SERVICE BULLETIN

Classification: FA15-003a	Reference: NTB15-062a	Date: October 22, 2015
------------------------------	--------------------------	---------------------------

2014-2015 ROGUE; POPPING NOISE FROM FRONT SUSPENSION WHEN TURNING

APPLIED VEHICLE: 2014-2015 Rogue (T32)

Figure 1

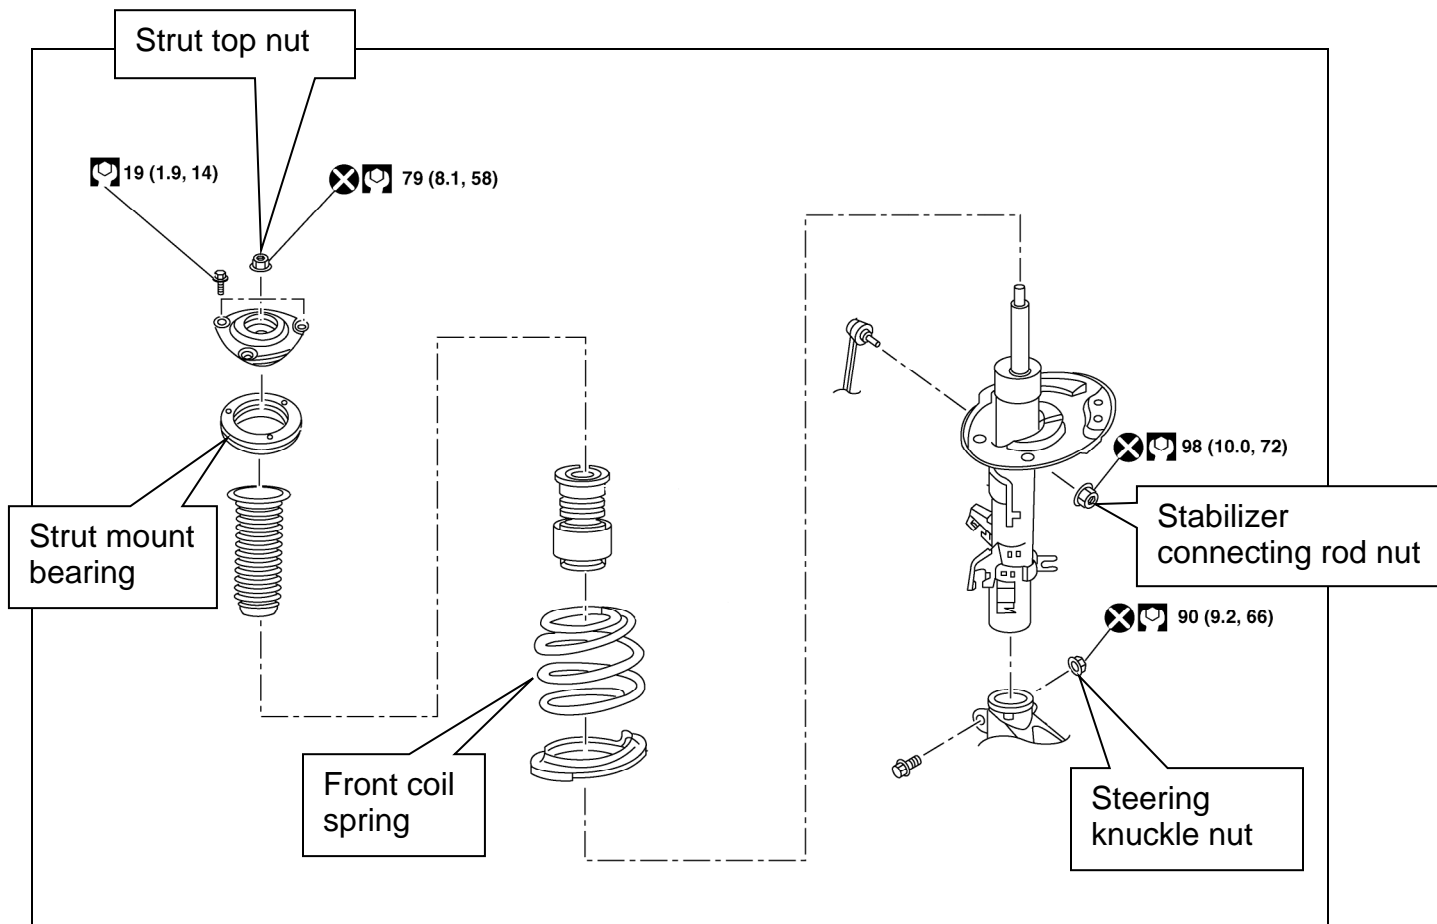
Replace both the front left and front right coil springs, front strut bearings and single use nuts (Figure 1) with those listed in the Parts Information table on the next page.
